**WNL6 - Reworking Fastening Screws on Rear Lid Hinge (Workshop Campaign)**

Vehicle Type: **718 Spyder (982)**

Model Year: **As of 2020 up to 2022**

*Installation position of lid hinge rear*

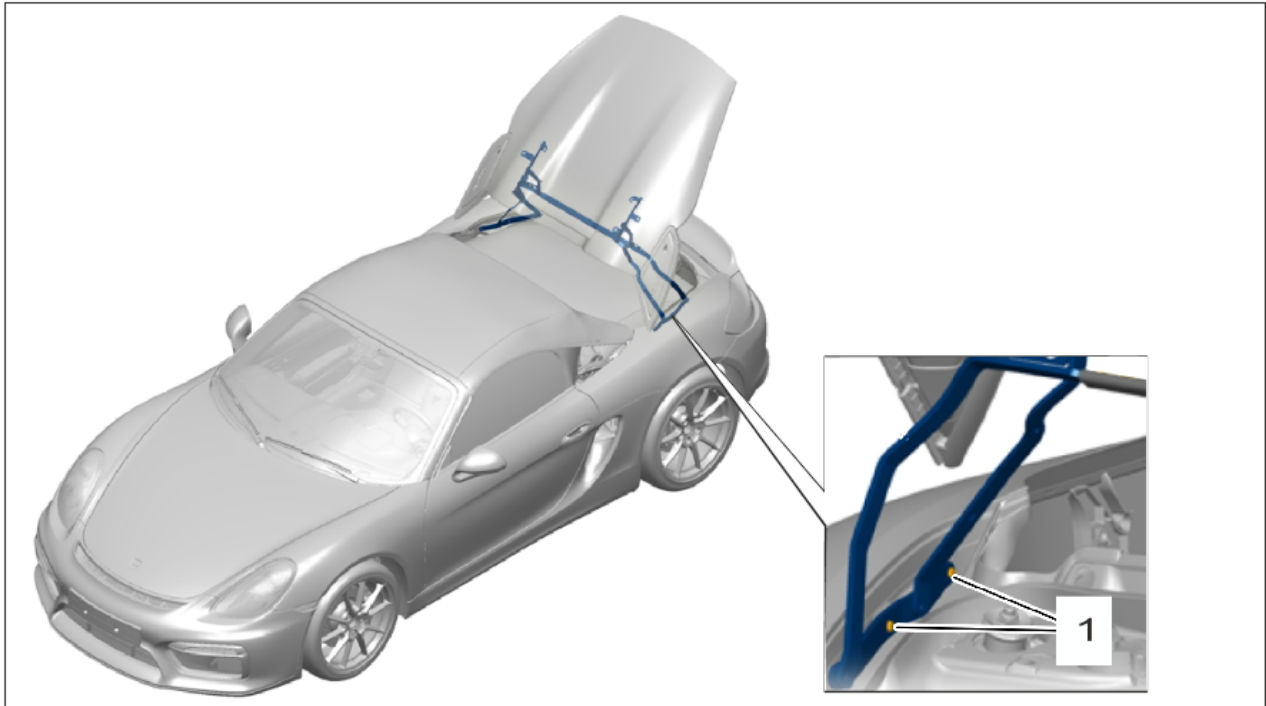
Information: **There is a possibility that the fastening screws on the rear lid hinge on the affected vehicles were not tightened to the specified tightening torque.**

This can result in reduced clamping force due to falling preload force over the service life of the vehicle, resulting in a visible change in the joint appearance between the lid and side panel.

- 1 – Fastening screws on rear lid hinge (rework)

Action required: Tighten fastening screws on the lid hinge to the specified tightening torque.

- Work Procedure:
- 1 Opening rear lid.
  - 2 Tighten fastening screws on lower lid hinge at the **left** and **right** to the specified tightening torque.  
**tightening torque 9.7 Nm (7.2 ftlb.)**
  - 3 Adjusting rear lid. ⇒ *Workshop Manual '55901530 Adjusting rear lid'*
  - 4 Close the rear lid .
  - 5 Enter the campaign in the Warranty and Maintenance booklet.
